ATEC
 FRAMEWORK DEVELOPMENT PLAN
 AURORA, COLORADO

MASTER PLAN NARRATIVE

PUBLIC IMPROVEMENTS PLAN

PUBLIC IMPROVEMENT PLANS
PLANNING AREA 10 - INFRASTRUCTURE

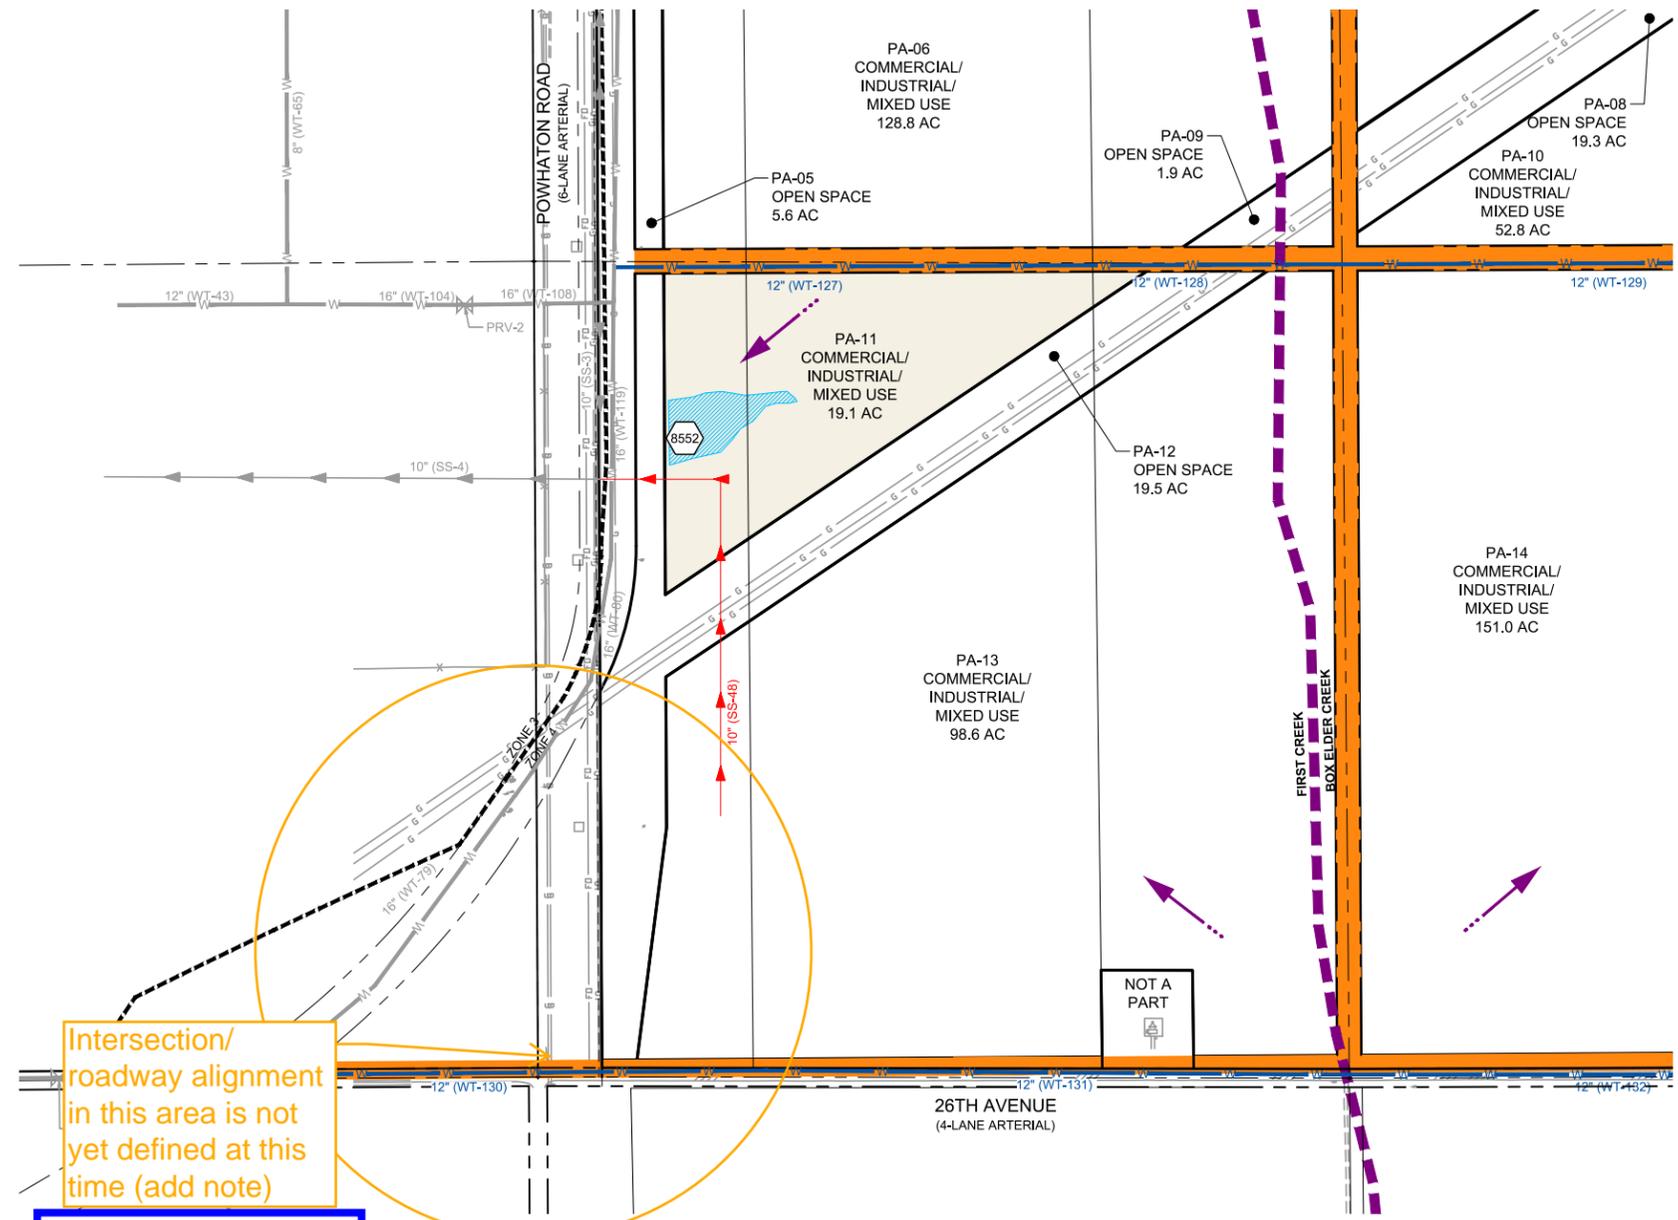
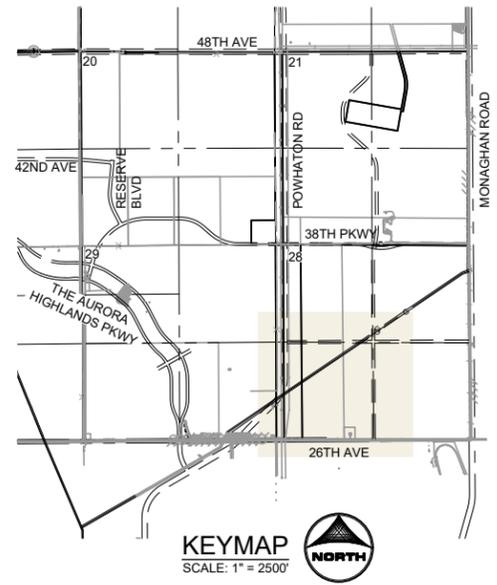
Intersection/
roadway alignment
in this area is not
yet defined at this
time (add note)

Note added to Overall
Infrastructure Plan

PUBLIC IMPROVEMENT PLANS
PLANNING AREA 11 - INFRASTRUCTURE

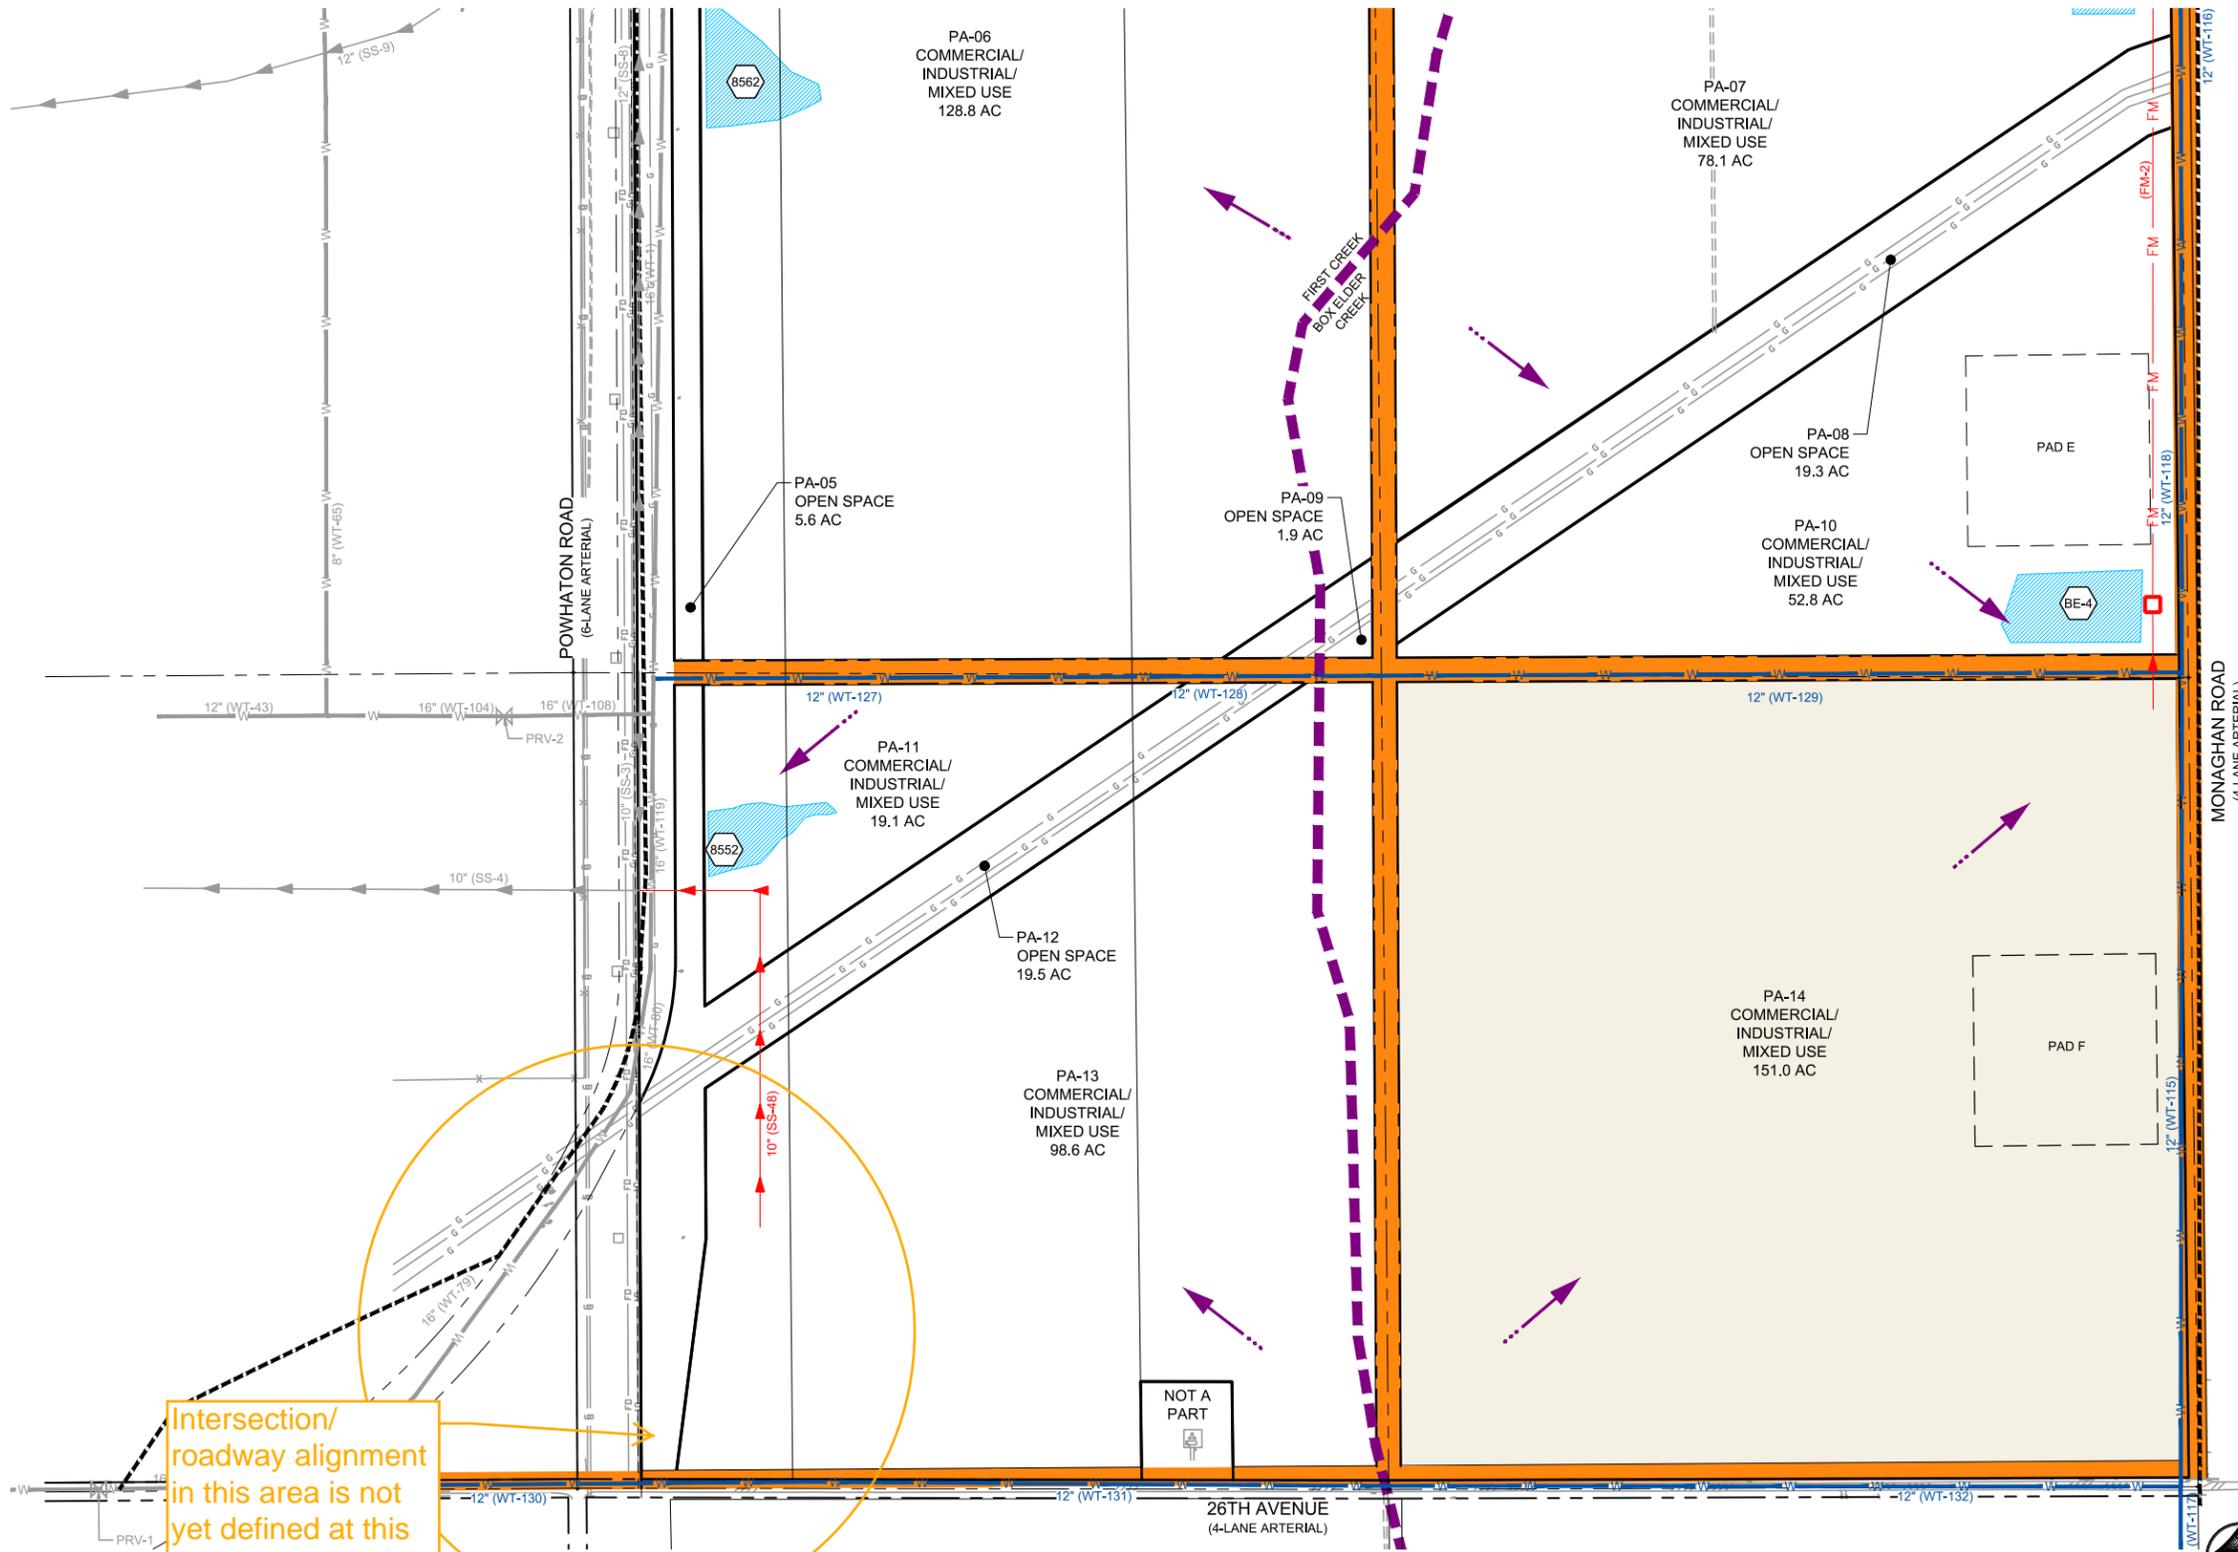
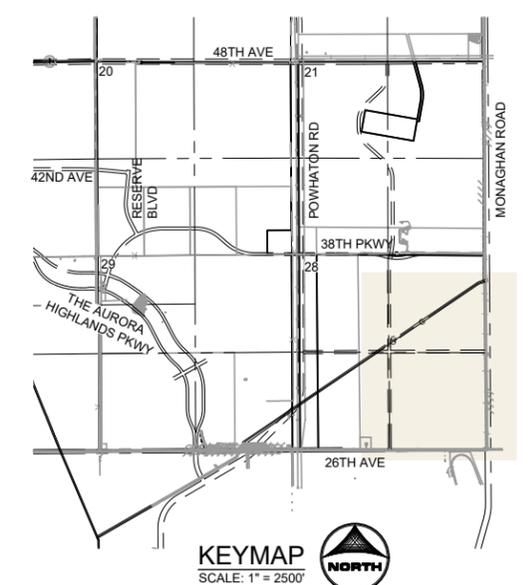
Intersection/
roadway alignment
in this area is not
yet defined at this
time (add note)

Note added to Overall
Infrastructure Plan

ILLUSTRATION TO LEGAL DESCRIPTION

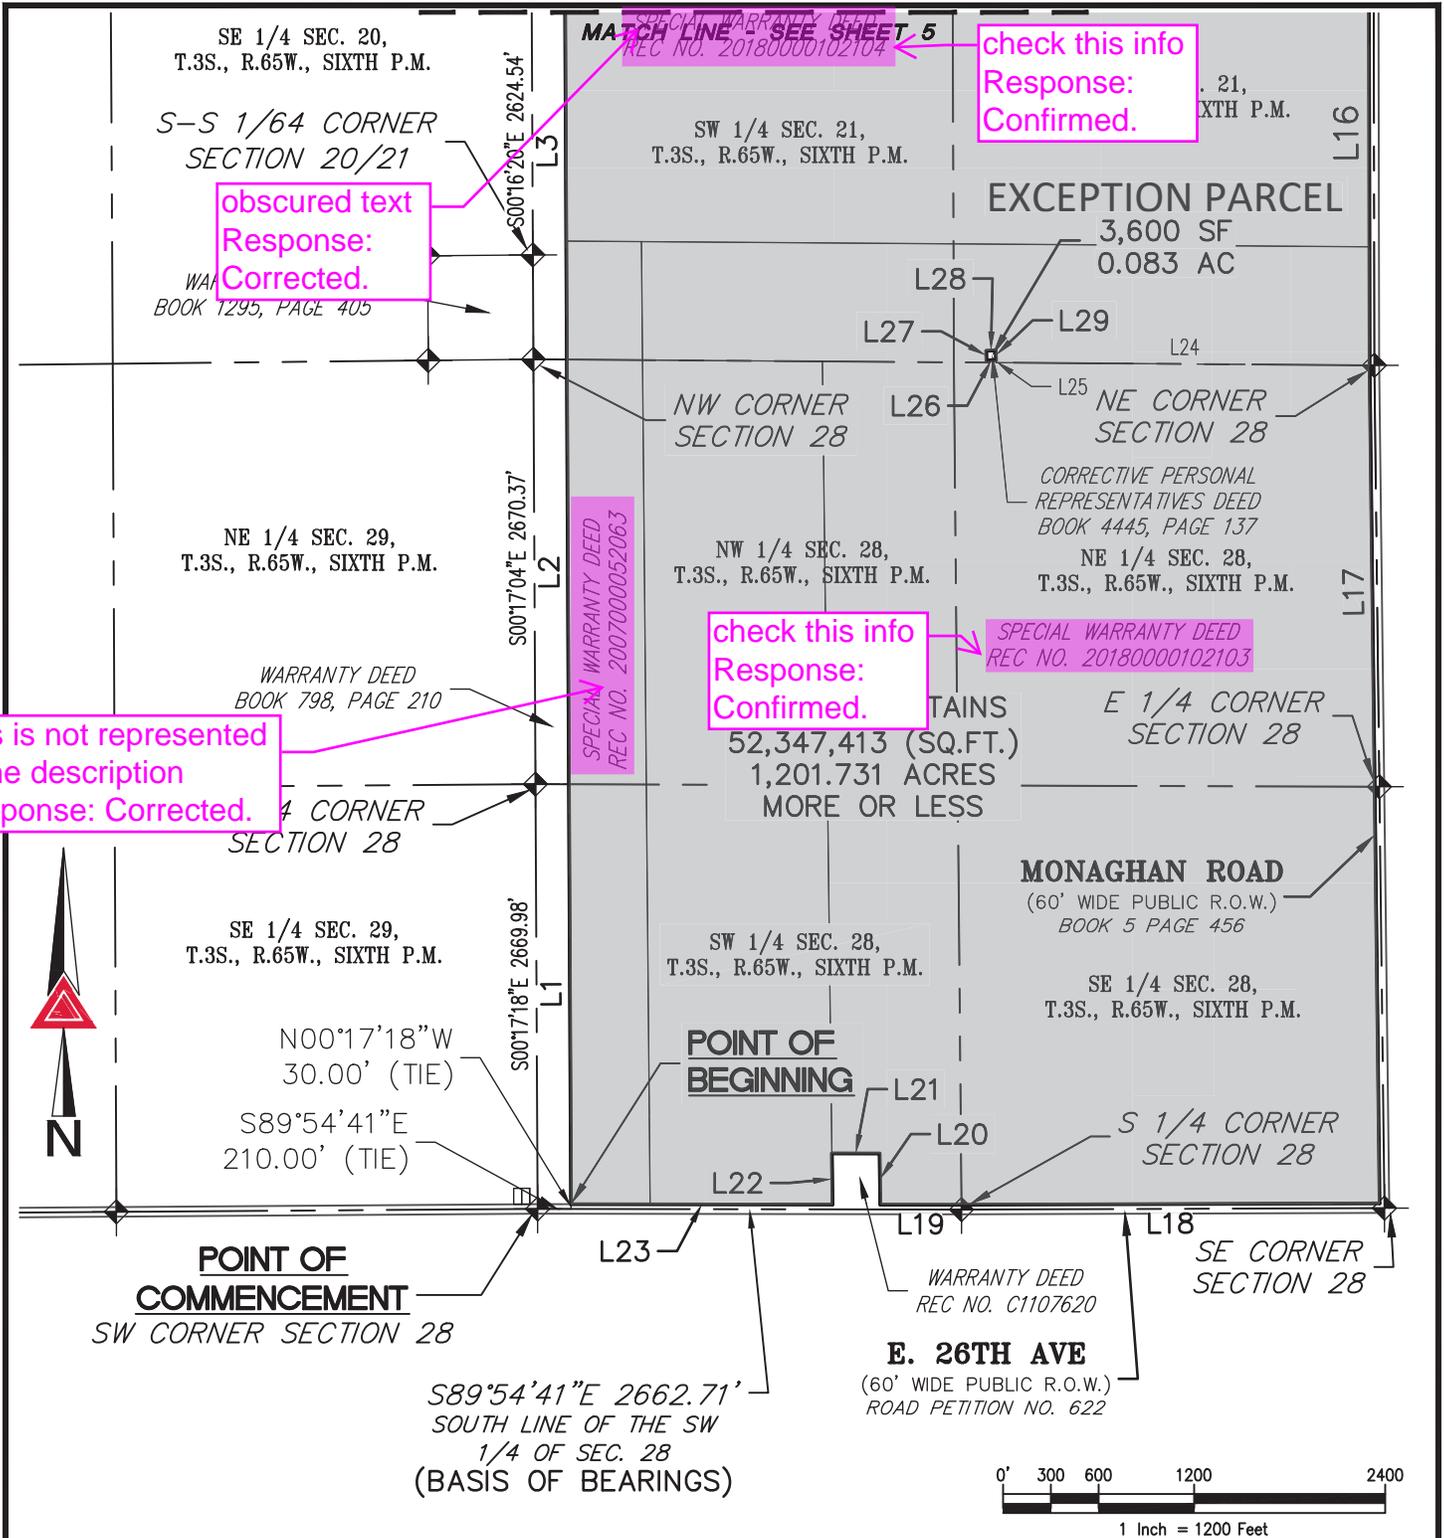
obscured text
Response:
Corrected.
